FINAL PLAT
REGENCY LAKES COMMERCIAL ADDITION
AN ADDITION TO WICHITA, SEDGWICK COUNTY KANSAS

RE: S/D 9898 - One-Step Final Plat of REGENCY LAKES COMMERCIAL ADDITION

At the regular meeting of the Subdivision Committee of the Metropolitan Area Planning Commission on Thursday, October 23, 1998, the above captioned plat was considered. The action of the Committee was to recommend that this plat be approved subject to:

CASE NUMBER: S/D 98-98 - REGENCY LAKES COMMERCIAL

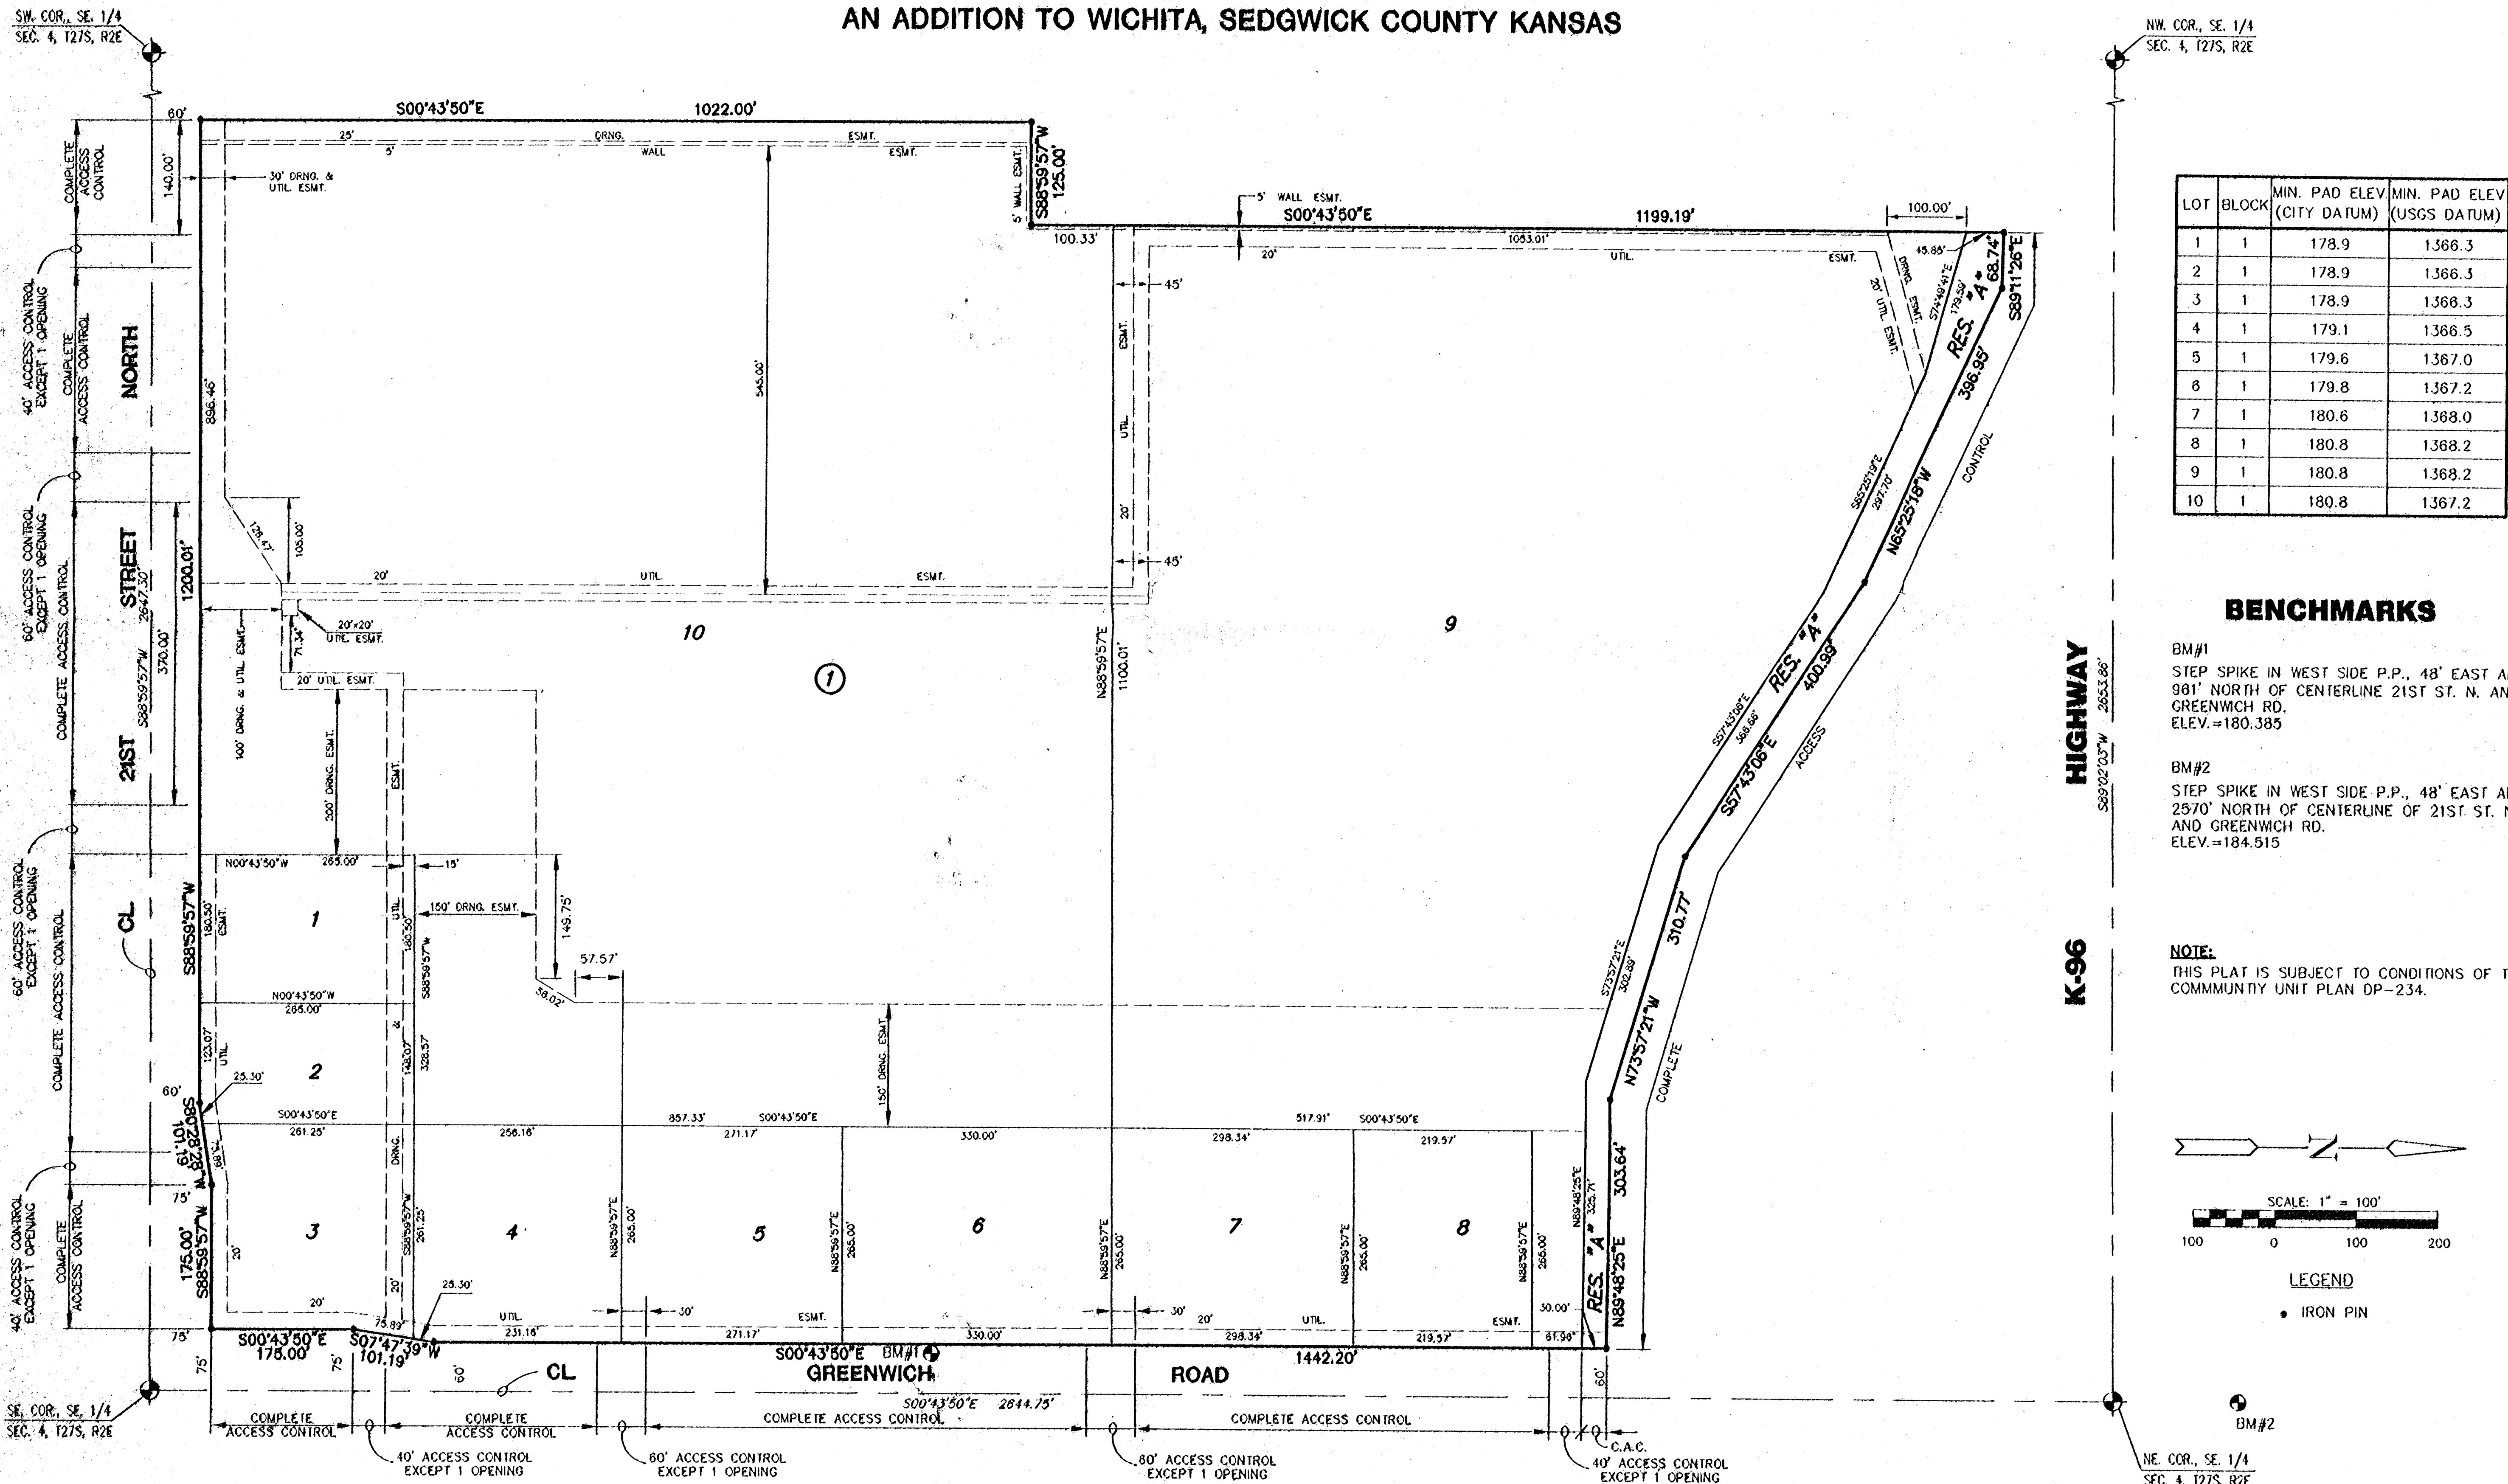
- D. In accordance with the CUP, a 5-ft wall easement needs to be platted along the west line of the plat, and shall be referenced in the plat's text.
- E. Traffic Engineering needs to comment on the need for improvements to 21st St. North and/or Greenwich. *An accel/decel lane along Greenwich will be required. The Applicant is requested to contact the developer of the Manhattan Addition to the east regarding participation in the petition for a center left-turn lane.*

- F. In accordance with the CUP, Reserve A adjoining K-96 is required to be eliminated from the CUP. This portion of the site, proposed for K-96 interchange

improvements, shall not be included within the plat's boundaries, and associated plat's text language needs to be removed.

H. Traffic Engineering needs to comment on the access controls. The CUP was approved with four points of access to 21st St. North and five to Greenwich Road. The plat denotes an additional access opening on Lot 2 along 21st St. North. The language in the plat's text regarding access to 21st St. North needs to correctly reference "Block 1". The number of access openings approved in the CUP are also approved for this plat. One opening along 21st St. North will need to be eliminated.

I. The Chairman of the MAPC needs to be revised to read, "William M. Johnson".

K. The tie points shall reference section "27S".

M. On the final plat tracing, a note shall be placed on the face of the plat indicating that this Addition is subject to the conditions of the Community Unit Plan DP-234.

O. The centerline of adjoining streets shall be indicated by "CL".

P. The plat's text shall properly reference "K.S.A. 12-512(b)".
